4. Revisions to the Draft Environmental Impact Report

In accordance with Section 15132 of the State CEQA Guidelines, this section presents the changes and revisions that were made to the EIR in response to comments received on the Draft EIR. Revisions made merely clarify information presented in the Draft EIR and only minor technical changes or additions have been made. These changes and additions to the Draft EIR do not raise important new issues about significant effects on the environment. Such changes are insignificant as the term is used in Section 15088.5(b) of the State CEQA Guidelines.

Figure D.2-3. Ozone – Number of Days Exceeding the 1-Hr CAAQS and 8-hr NAAQS CAAQS (1997-2006)

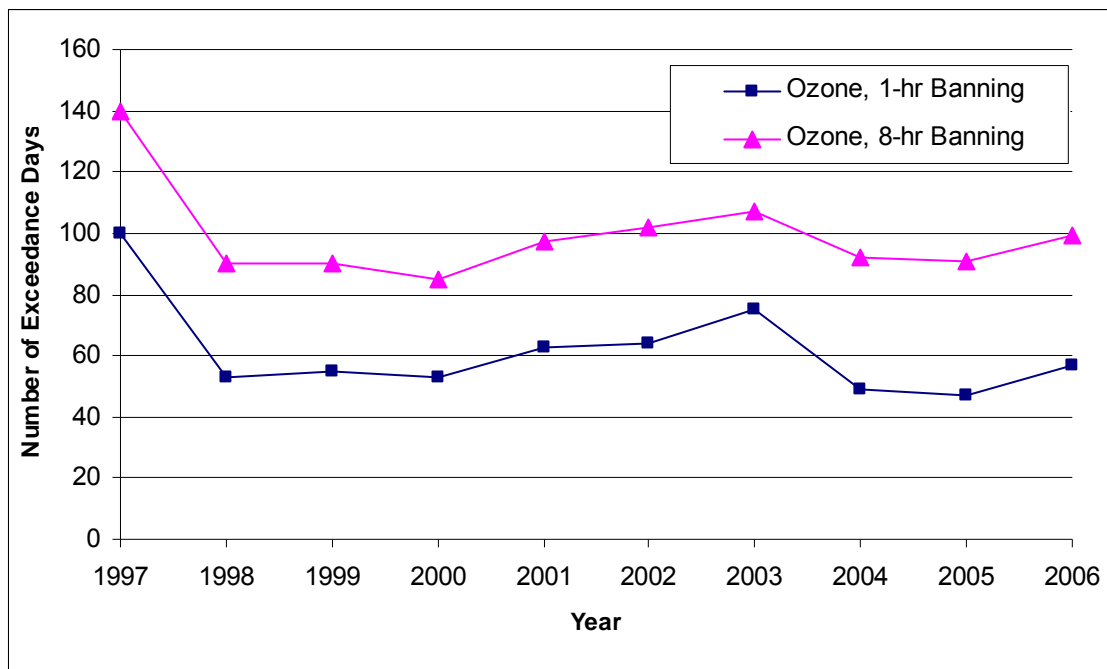
- Page D.2-5:
